# MEMORANDUM

**SUBJECT:** Public hearing and consideration of a Landmark Alteration Certificate to demolish a non-contributing building at 1023 Walnut St. in the Downtown Historic District and in its place construct a new four-story commercial building to be connected via a bridge to the proposed building at 1048 Pearl St., amending the Landmarks Board September 19, 2012 approval by the Landmarks Board with conditions (HIS2012-00181).

Memo to the Landmarks Board  
Re: Landmark Alteration Certificate review of 1023 Walnut Street

**1023 Walnut Street, 2012**  
**Existing building constructed in 1986 proposed for demolition**

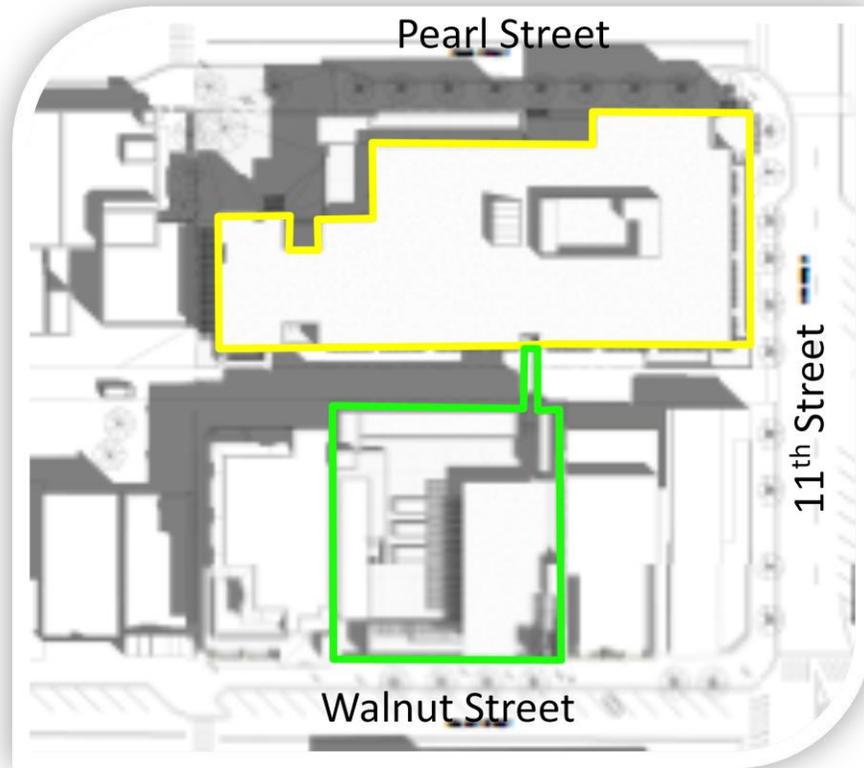
The existing building at 1023 Walnut Street was constructed in 1986, prior to the establishment of the Downtown Historic District. Architecturally it is incongruent with the streetscape presently with a relatively blank façade to the 1000 block of Walnut Street. Because the building was constructed out of the period of significance of the Downtown Historic District (1858-1946), lacks architectural distinctiveness, and detracts from the historic character of this edge of the district.

Current proposal, west elevation (shaded areas)

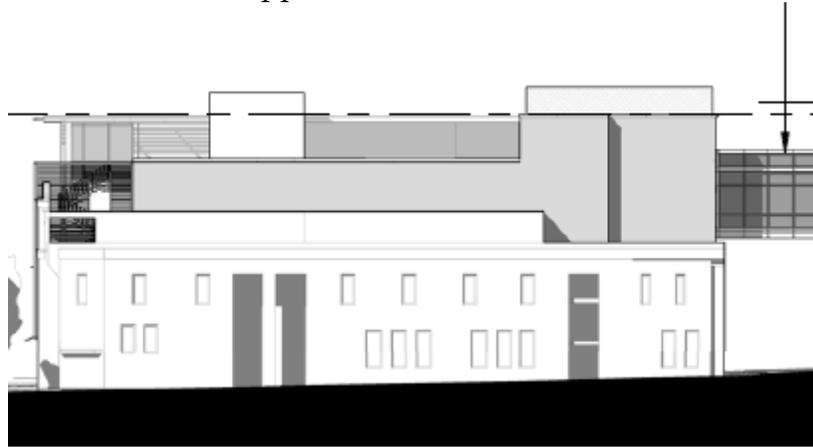
Elevations show the north face of the building to have changed in design to significantly reduce the height and width of the alley span from two levels to one, and from approximately 35' in width to about 10' in width. The alley level shows two doors accessing automated parking while the second and third elevations are shown to be fenestrated in a manner similar to that of the façade. A renewed Air Rights Lease will be required to establish the alley span, prior to building permit application.
